# UNITED STATES PATENT AND TRADEMARK OFFICE

APPLICATION NO.	FILING DATE	FIRST NAMED INVENTOR	ATTORNEY DOCKET NO.	CONFIRMATION NO.
09/838,348	04/19/2001	Randall W. Ojanen	K-1786	2490
7590 Kennametal Inc. P.O. Box 231 Latrobe, PA 15650			EXAMINER SINGH, SUNIL	
			ART UNIT	PAPER NUMBER
			3673	
SHORTENED STATUTORY PERIOD OF RESPONSE		MAIL DATE	DELIVERY MODE	
3 MONTHS		02/08/2007	PAPER

**Office Action Summary**

## **DETAILED ACTION**

Fig. 15

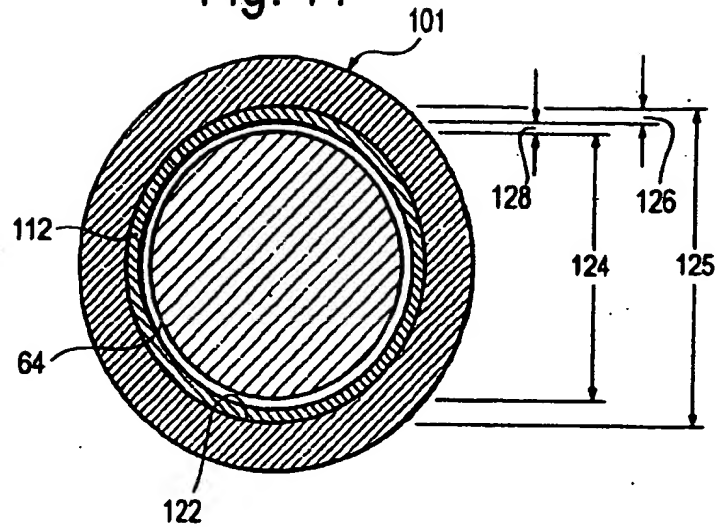
a cutting tool (10") a retainer sleeve (38") carried by the cutting tool, and including at least one radially outward protruding surface (31); wherein said retainer has a cylindrical circumference and a thickness dimension, the amount of radial projection of said protruding surface beyond the cylindrical surface of the retainer is between about 15 percent and about 30 percent of the thickness dimension of said retainer (see attached marked up Fig. 15).

With regards to the limitation that the "dimple extends between about .007-.020 inches beyond the exterior cylindrical surface of said sleeve", see attached marked up Figure 15, member (41) is defined at col. 6 line 55 as being .1875 inches and it was determined by measurement that the dimple extends about .0375 inches from the exterior of the sleeve thus meeting the limitation about ".007-.020" inches.

With regards to the limitation that the "diameter is between .06-.10 inches, see attached marked up Figure 15, member (41) is defined at col. 6 line 55 as being .1875 inches and it was determined by measurement that the dimple extends about .0375 inches from the exterior of the sleeve thus meeting the limitation about ".06-.10" inches in diameter.

8. Applicant's arguments filed in appeal brief (filed 10/7/05) have been fully considered but they are not persuasive. Applicant argues that the dimple thickness is about 88.9% the thickness of the sleeve. The examiner disagrees. As pointed out in the attached marked up Figure 15, member (41) is defined at col. 6 line 55 as being .1875 inches and it was determined by measurement that the dimple thickness is about .0375 inches and the sleeve thickness is about .125 inches thus meeting the limitation about 15-30%.
